Service Letter SL 53 R4	DO - No. EASA.21J.020
--	------------------------------------	----------------------------------

Modification of fluid deice system

Fluid Deice Assy P-909-14-3

MTV-14-D/195-30b installed on Cirrus SR22-() with spinner assy P-320-2.

Fig.5

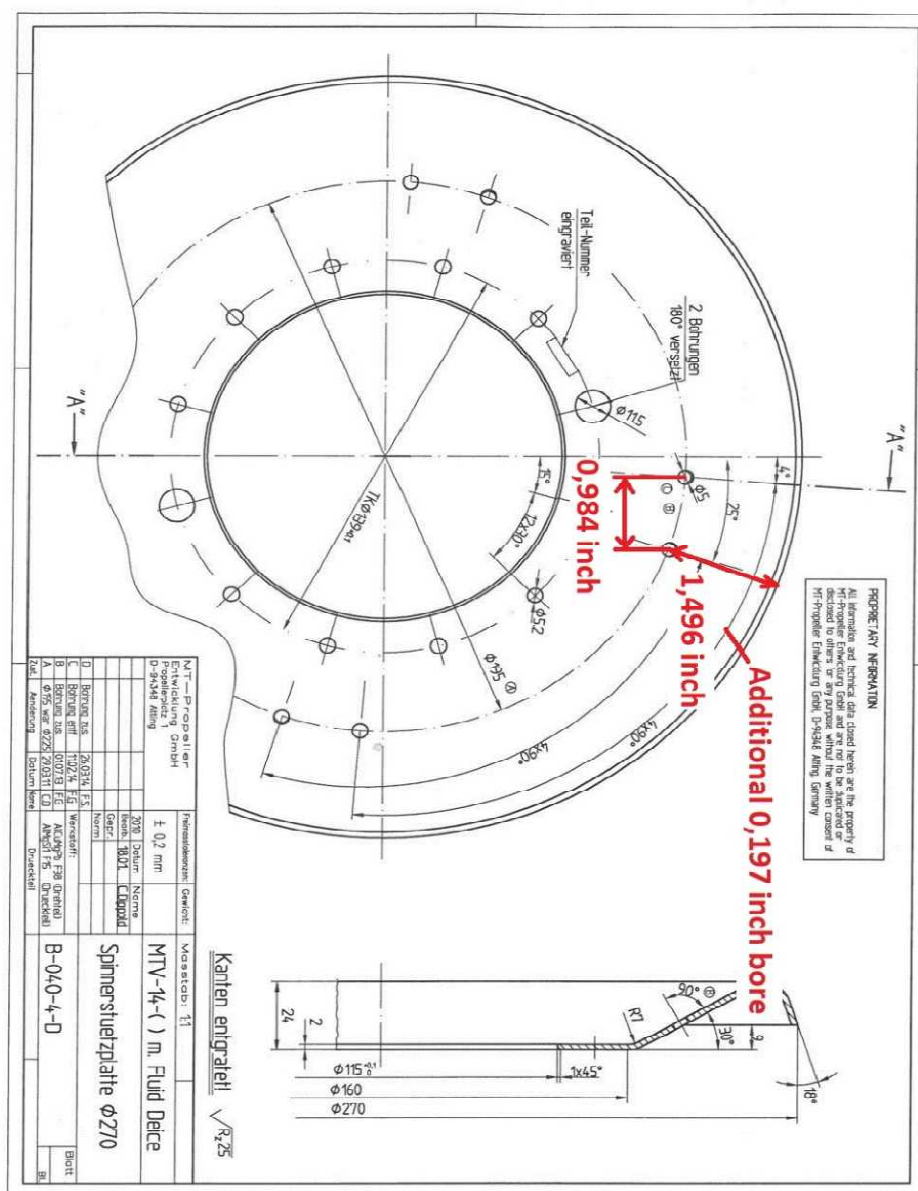
4. Modify the spinner front plate with an additional 0,197 inch (5mm) bore according to Fig.5
5. Install the bracket (A-1909-1), the clamp (C-149), the rubber damper (C-470), and the screws according to Fig. 1.
